Our Ref: 11003/140612ltr

Re: ADAMSTOWN RSL CLUB – RESPONSE TO URBAN DESIGN REVIEW PANEL

Please find the following responses to the Panel Meeting of 23 May 2012, in which the proposed development at 282 Brunker Road Adamstown was discussed. This has been broken down into subsections, as per the report itself, in order to provide clarity in our response to the Urban Design Review Panel

Figure 1: Extract from Newcastle City Council Draft LEP Height Maps.

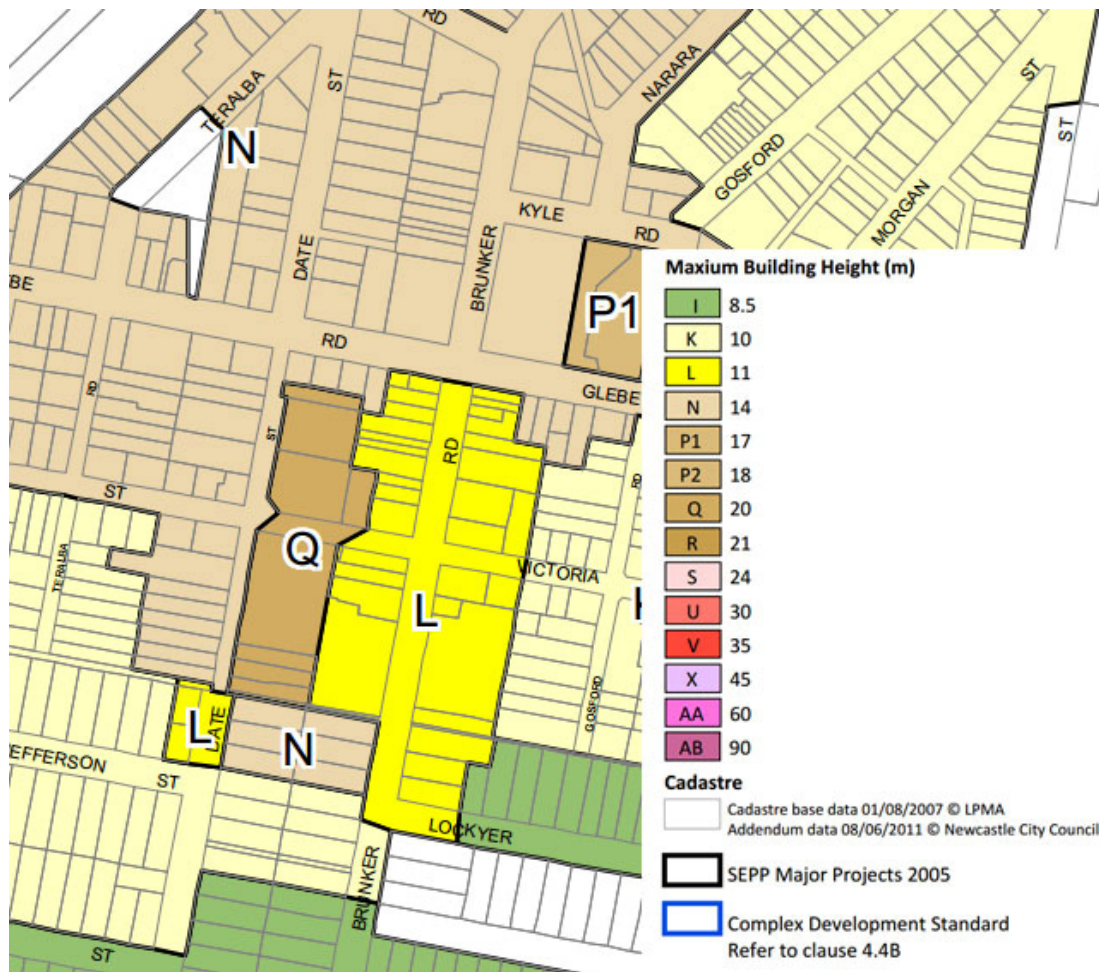
As per the response to the context of the site above, the scale of the proposed development is designed to reflect the expressed desire of Council to regenerate and increase the density of this area. It is noted that the properties on the western side of Date Street are currently predominately single and two storey dwelling houses. However, the Height Mapping of the Draft LEP clearly shows the desired future scale and height of this area. And that desired future scale is for medium and high density residential development. This will mean that the maximum height of the area will increase to 14m. This is illustrated in Figure 1 below.

The height and scale of the proposed development forms a transition between the commercial development along Brunker Road and the proposed 14m maximum height residential area to the west of the site.
